RECEIVED
APR 20 2001
HYDROLOGY SECTION

REV.	DATE	DESCRIPTION
PROJECT TITLE		
Corona Del Sol Townhomes		
Sequoia and Arcata Ct.		
Albuquerque, NM		
SHEET TITLE		
Drainage Plan		
CAMI		
CONSTRUCTION ANALYSIS & MANAGEMENT, INC.		
DRAWN BY: BEH		
CHK'D BY: Raymond Henley, P.E.		
DATE: 04/20/2001		
D1

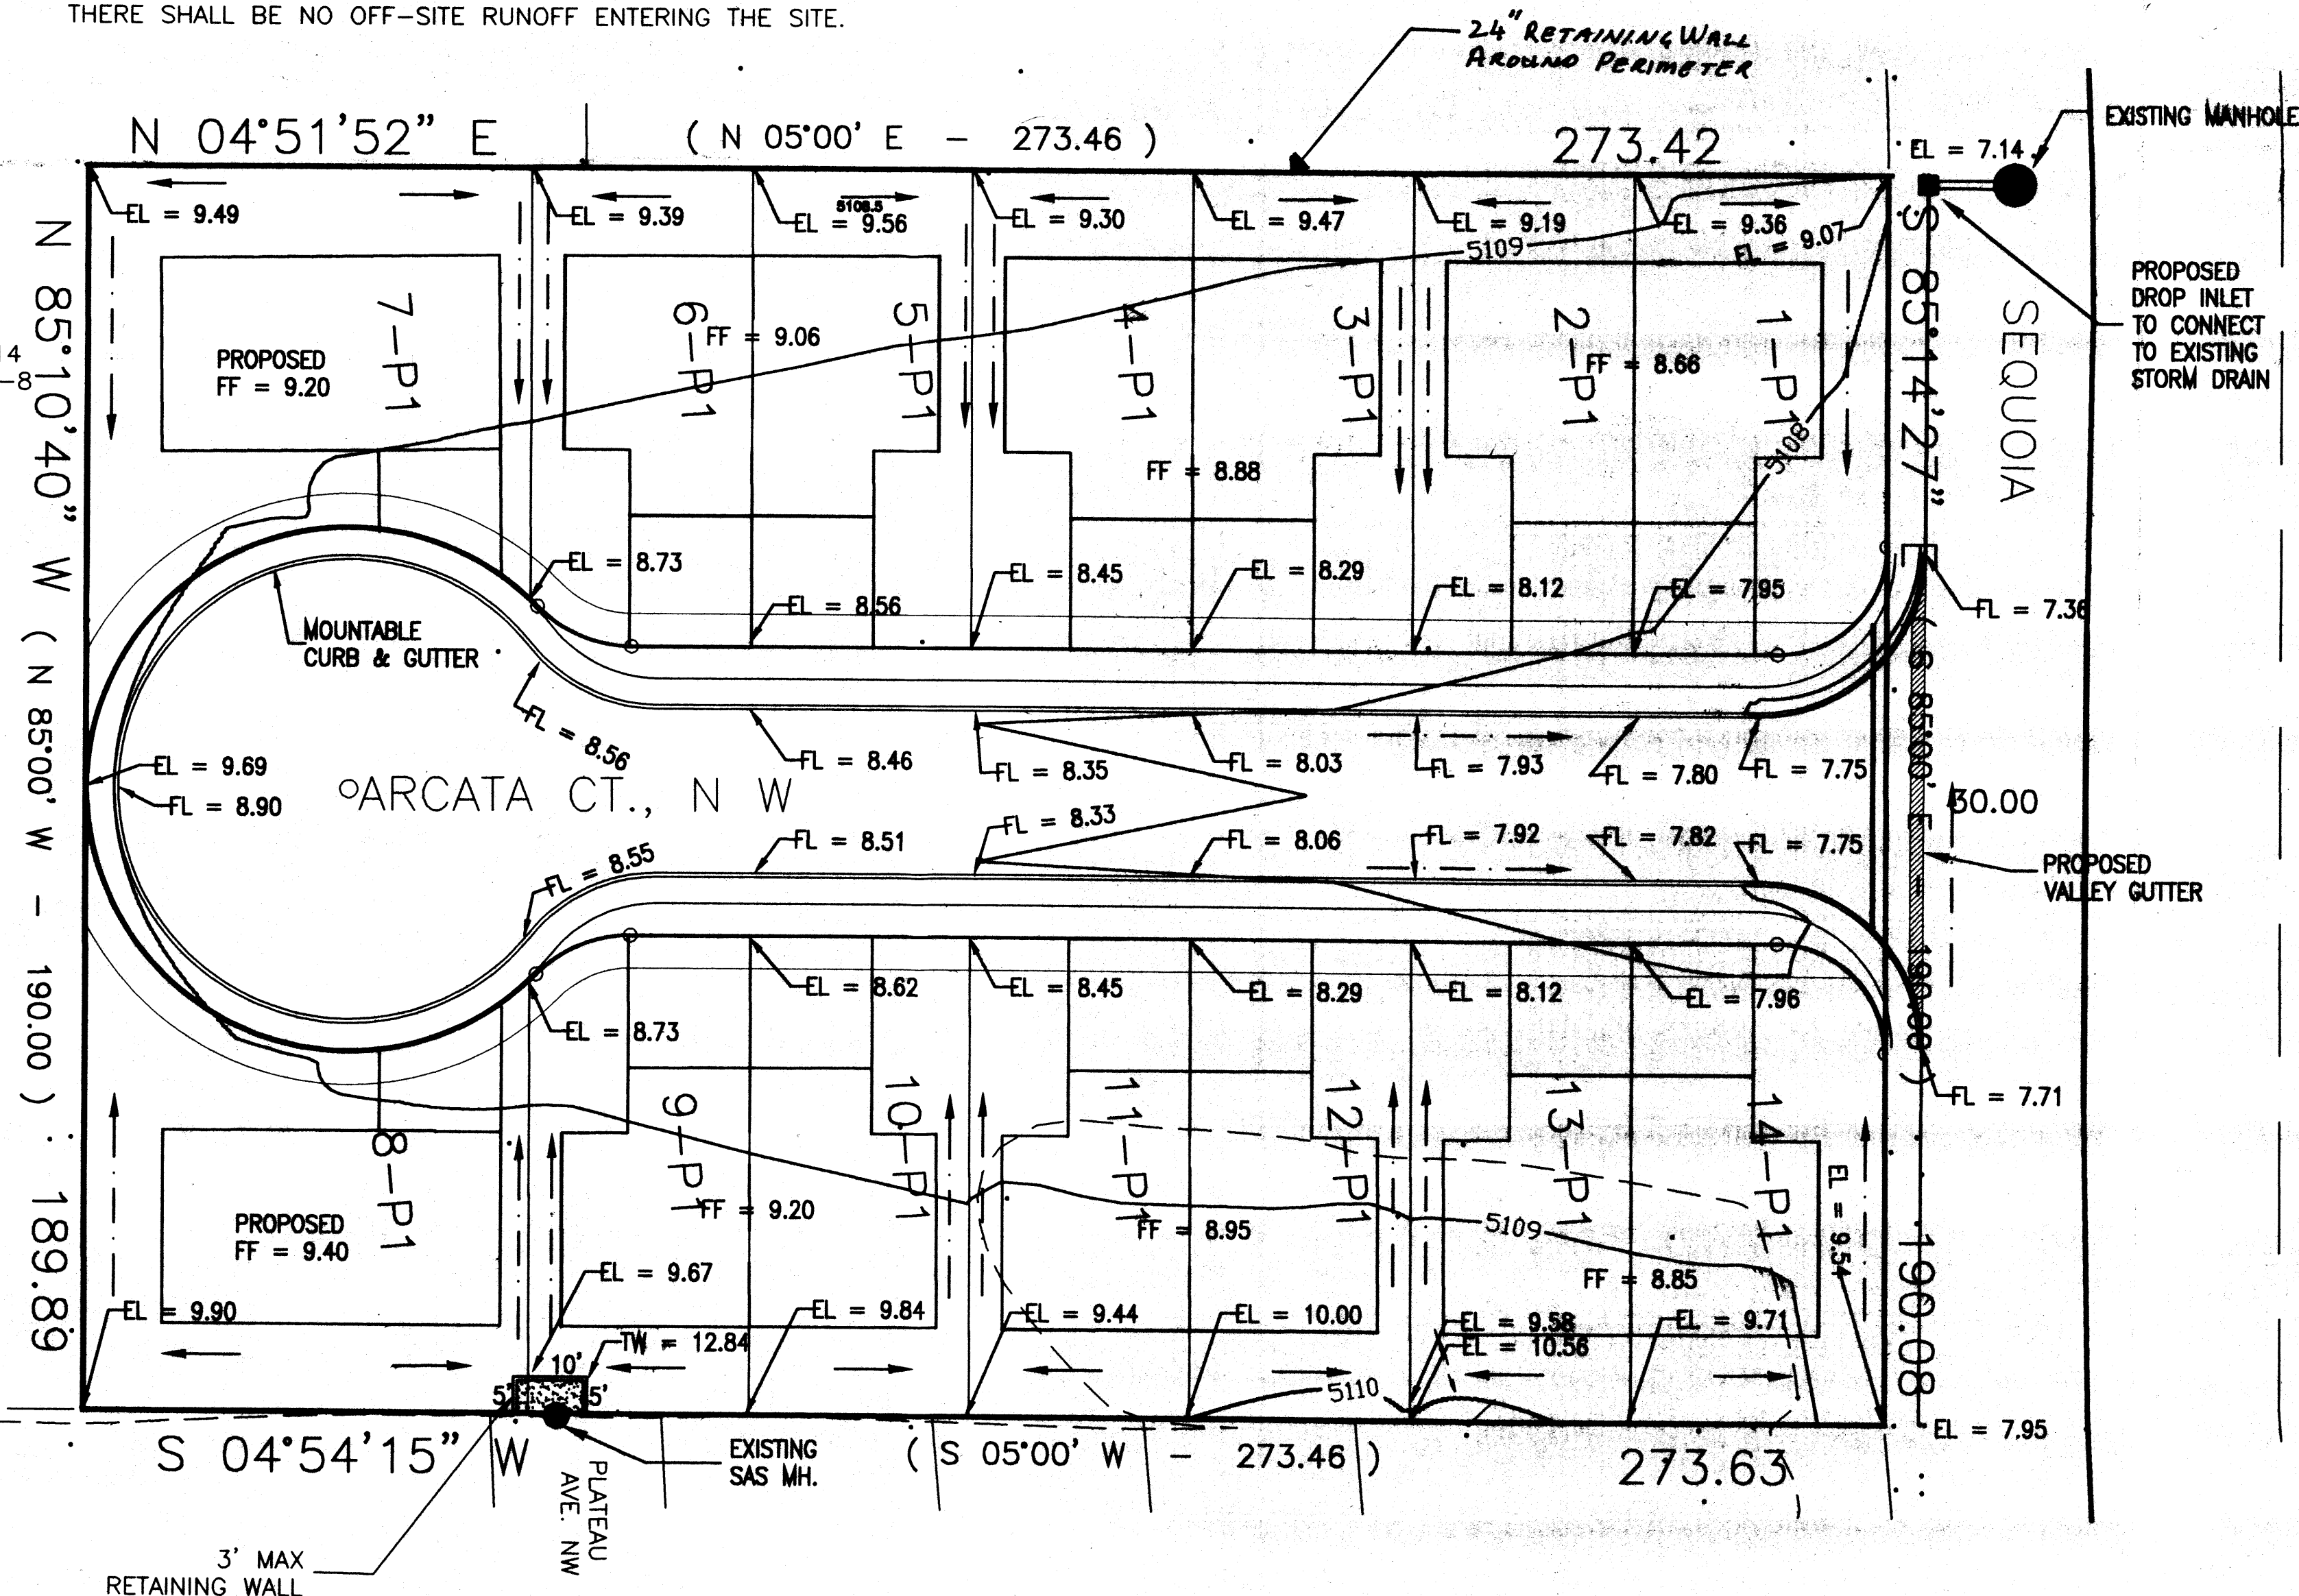
Approved 4/23/01
needs spot elev's.
on surrounding
area.
